Commonwealth Edison

February 15, 1985

Subject: Braidwood and Byron Stations
Supplemental Response to Generic Letter
No. 83-28, "Required Actions Based on
Generic Implications of Salem ATWS Events"
NRC Docket Nos. 50-454/455 and 456/457

FIGURE 2

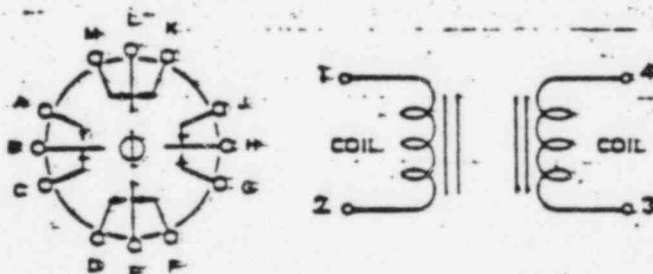
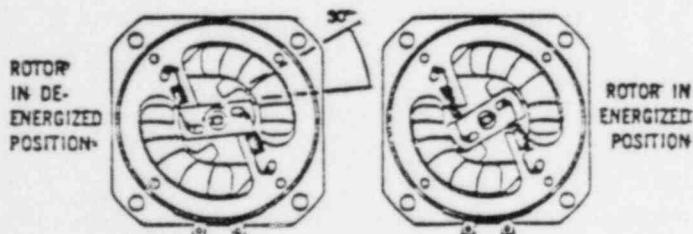
"Verify that the relays added for the automatic shunt trip function are within the capacity of their associated power supplies and that the relay contacts are adequately sized to accomplish the shunt trip function. If the added relays are other than the Potter & Brumfield MDR series relays (P/N 2383A38 or P/N 955655) recommended by Westinghouse, provide a description of the relays and their design specifications."

"Verify that the relays added for the automatic shunt trip function are within the capacity of their associated power supplies and that the relay contacts are adequately sized to accomplish the shunt trip function. If the added relays are other than the Potter & Brumfield MDR series relays (P/N 2383A38 or P/N 955655) recommended by Westinghouse, provide a description of the relays and their design specifications."

It has been verified that the relay contacts are adequately sized for the shunt trip function and are within the capacity of their associated power supplies. The added relays specified in the generic design are the Potter and Brumfield MDR series relays (P/N 2383A38 (125 VDC) or P/N 955655 (48 VDC)). Engineering data for the selected Potter Brumfield MDR relays is attached (Figure 2).

It has been verified that the relay contacts are adequately sized for the shunt trip function and are within the capacity of their associated power supplies. The added relays specified in the generic design are the Potter and Brumfield MDR series relays (P/N 2383A38 (125 VDC) or P/N 955655 (48 VDC)). Engineering data for the selected Potter Brumfield MDR relays is attached (Figure 2).
